WT20-001

ITB20-003

2014-2020 Q50 AND 2017-2020 Q60; TPMS SENSOR LEAKING AIR

APPLIED VEHICLES: 2014-2020 Q50 (C37)
2017-2020 Q60 (CV37)

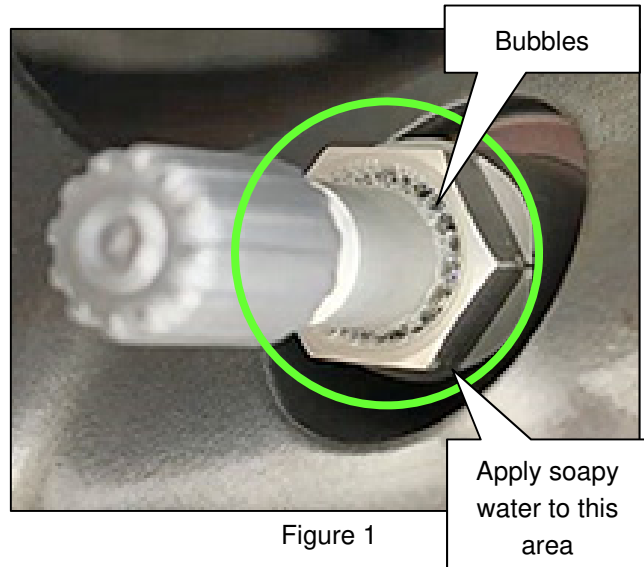
2. Apply a mixture of soap and water to the area shown in Figure 1.

3. Visually inspect for bubbles in the area between the valve stem and the valve nut.

- If bubbles were found in the area shown in Figure 1, proceed to step 4.
- If no bubbles were found, this bulletin does not apply. Further inspection may be necessary to locate a wheel/tire leak that is not covered by this bulletin.

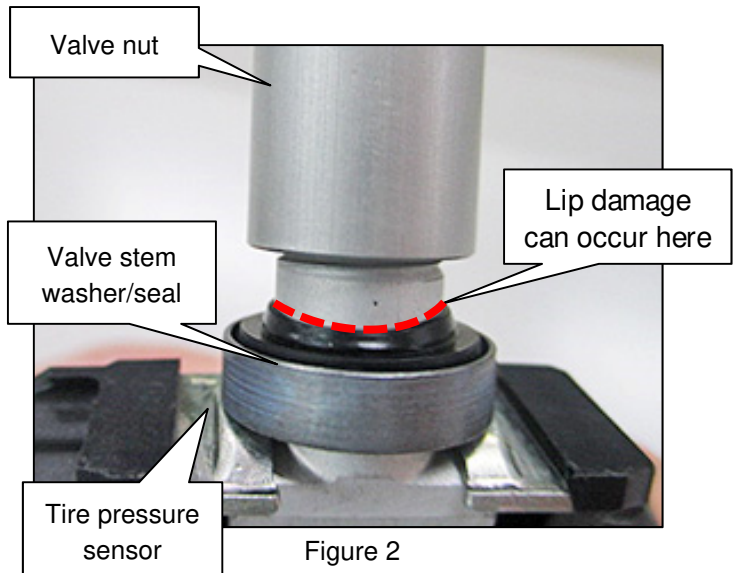
NOTICE Valve stem washer/seal lip damage may occur if the valve stem seal is not centered in the wheel. Take care to center the valve stem when installing into the wheel (see Figure 2).

6. Reinstall the tire pressure sensor into the wheel with a new valve nut from the PARTS INFORMATION on page 3, and then torque to the new specification below.

- Valve nut torque: 10 N•m $\pm$ 0.5 (1.02 kg-m, 88.5 in-lb)
